Subject: July 11th - 3913 Ave F. submission backup

Project: 3913 Avenue F

C15-2016-0060

**VARIANCE REQUESTED:** The applicant has requested variance(s) to Ordinance 020131-20 Part 8, 1 (*Site Development Standards Table*) to decrease the minimum rear yard setback from 10 feet (required/permitted) to 3 feet 6 inches (requested) in order to erect a new two-story garage with apartment in an "SF-3-H-HD-NCCD-NP", Family Residence – Historic Landmark - Historic Area – Neighborhood Conservation Combining District - Neighborhood Plan zoning district. (Hyde Park)

15' ALLEYS  
IN HYDE  
PARK

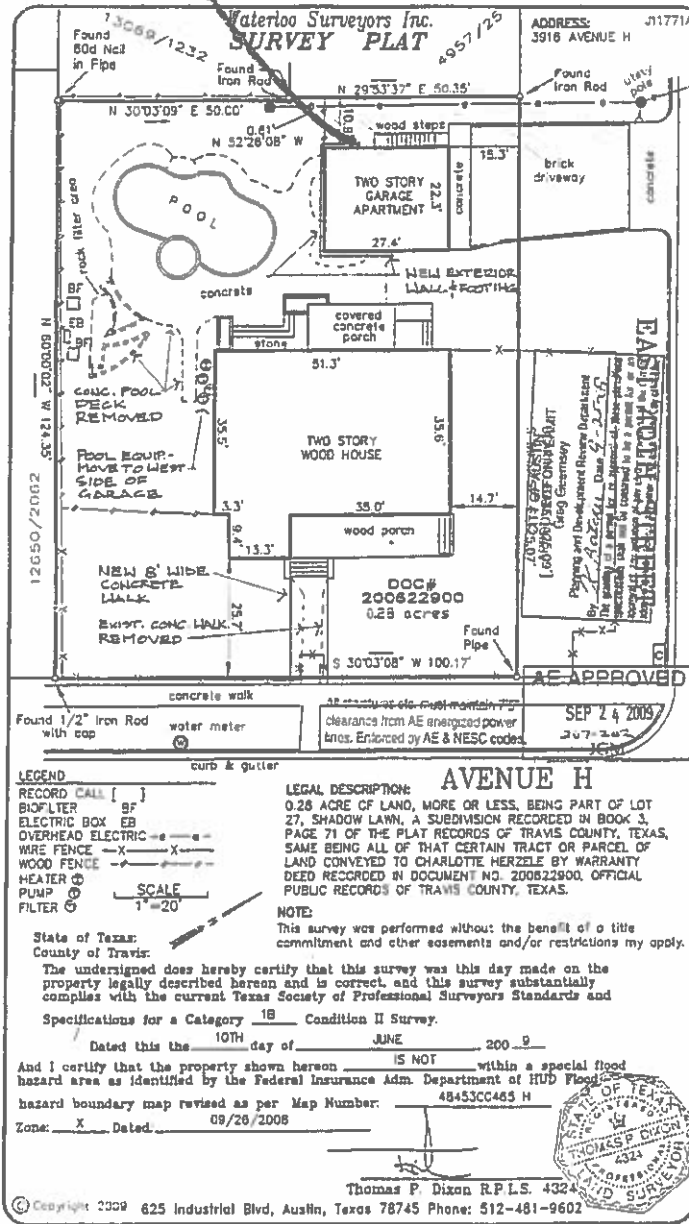
( NO ALLEYS IN  
SHADOWLAWN  
WHERE SET BACKS  
ARE VITAL for  
SEPARATION of  
STRUCTURES

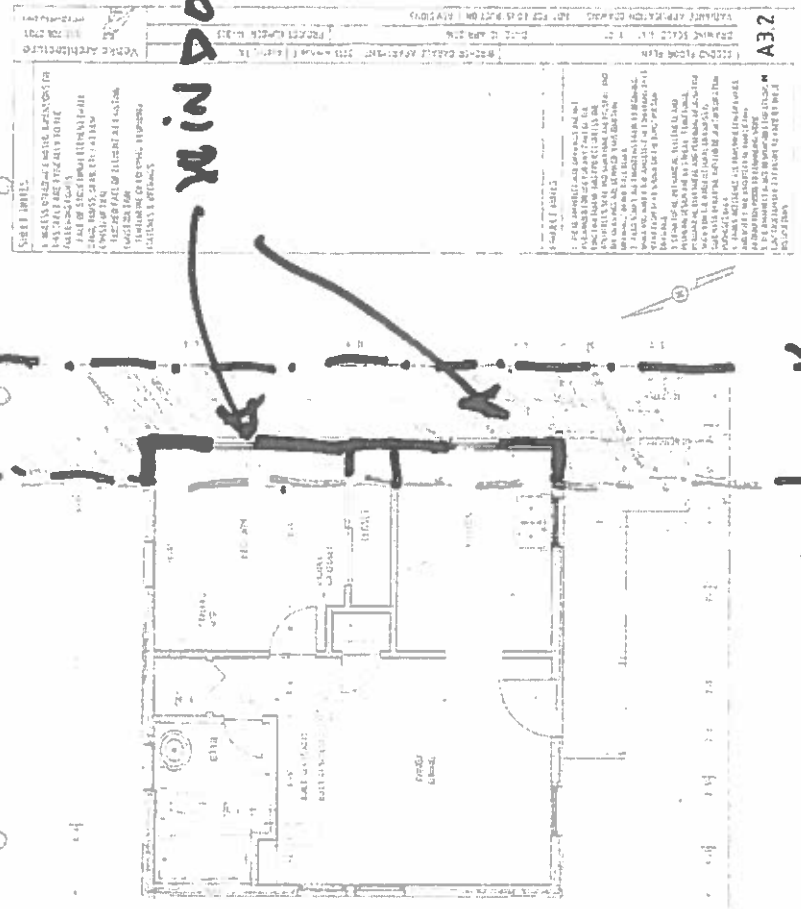
5' FIRE SEPARATION 5'-0"

REQ'S 1-FLOOR

FIRE RATING & NO WINDOWS  
UNLESS FIRE RATED

FRONT OF HOUSE (WEST)

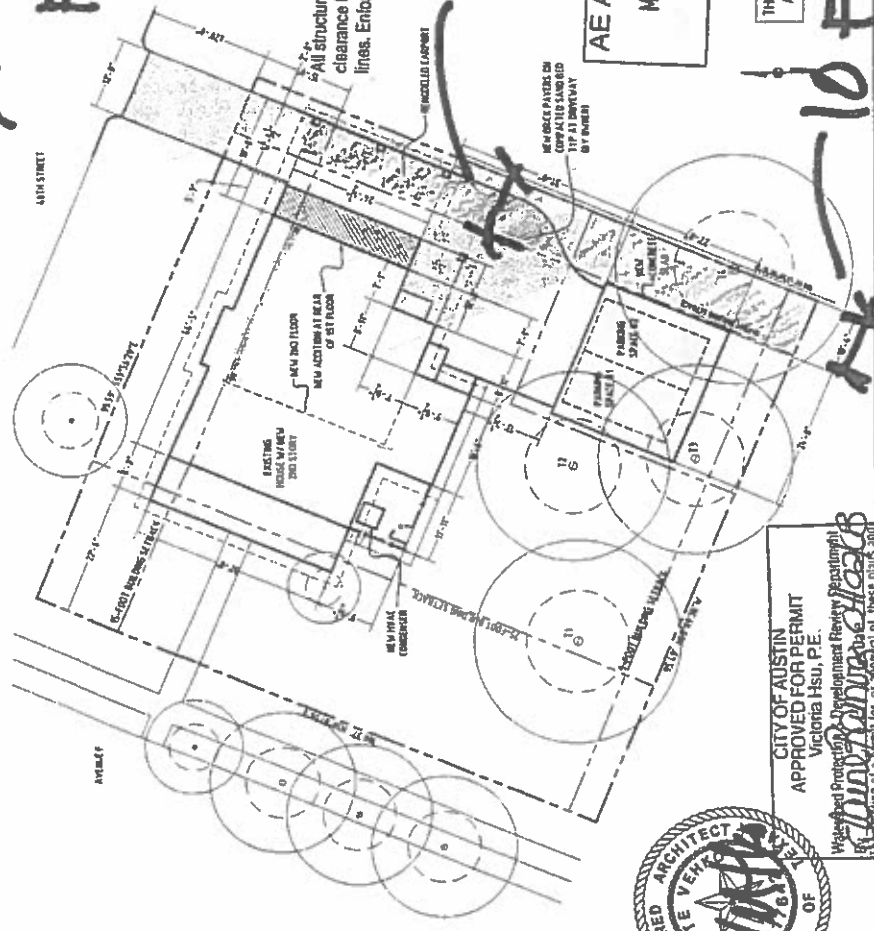
2008 APPROVED

PARKING

LOCATION

TURNING

RADIUS

NOT A

HARDSHIP

IN 2008

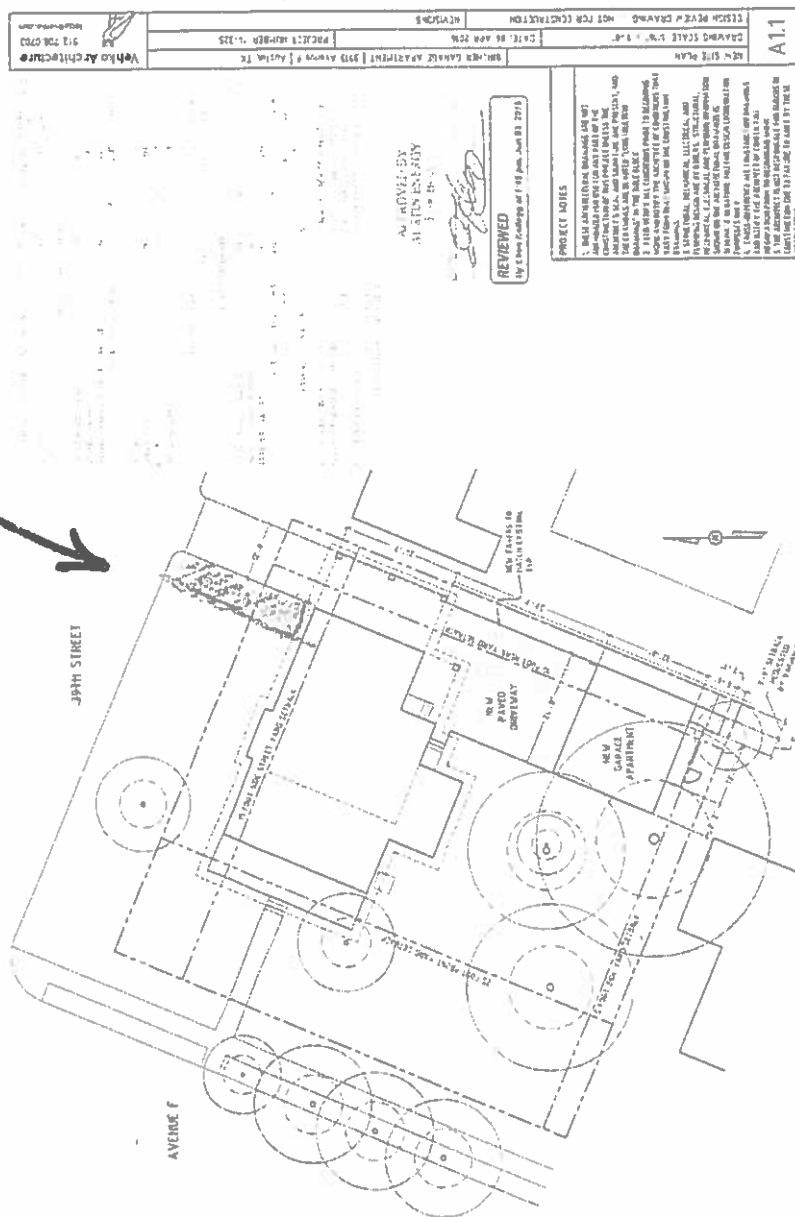
2008 APPROVED TREE  
 REMOVAL ALLOWS  
 FOR AVE. F CURB CUT.

A1.2	NEW SITE PLAN DRAWING SCALE: 1/16" = 1'-0"	BIRCHER GARAGE APARTMENT   3913 Avenue F   Austin, TX DATE: 20 JUN 2016	PROJECT NUMBER 14-325	Vehko Architecture 512.708.0703 lotte@vehko.com
	VARIANCE APPLICATION DRAWING -- NOT FOR CONSTRUCTION	REVISIONS

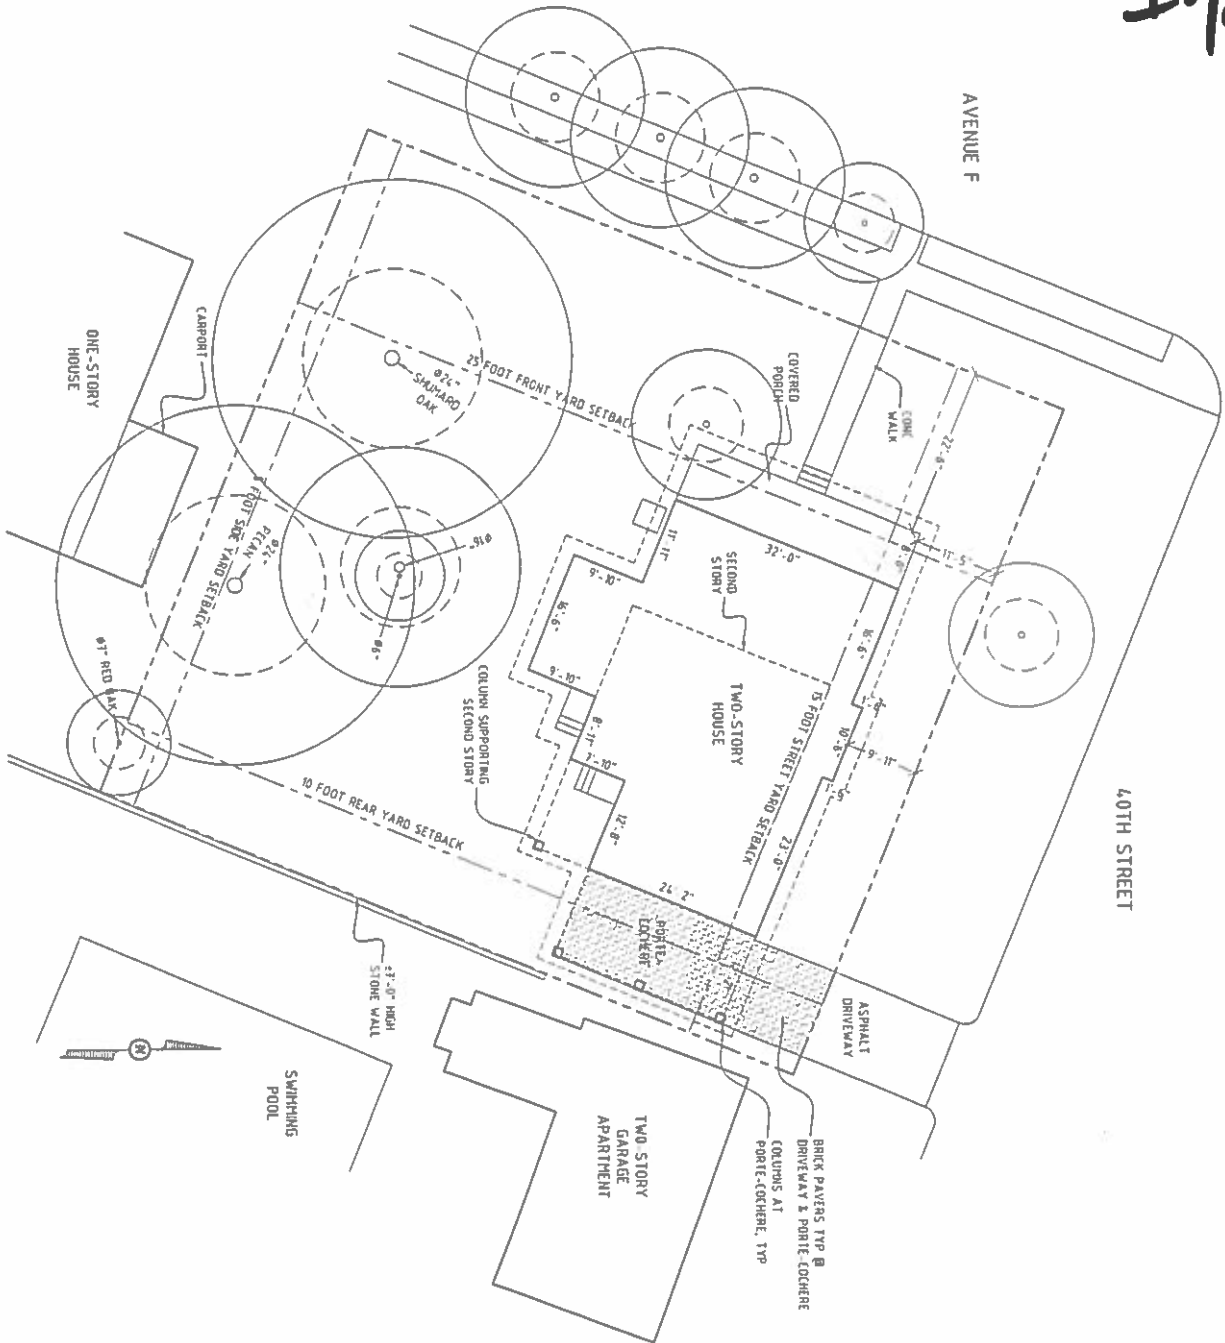
**BOARD'S DECISION:** The public hearing was closed on Board Member Melissa Hawthorne motion to Grant with condition to move garage forward 5 feet north towards 40<sup>th</sup> Street from current location on the plan, Board Member Michael Von Ohlen second on a 10-1 vote (Board member Bryan King nay); **GRANTED WITH CONDITION TO MOVE GARAGE FORWARD 5 FEET NORTH TOWARDS 40<sup>TH</sup> STREET FROM CURRENT LOCATION ON THE PLAN.**
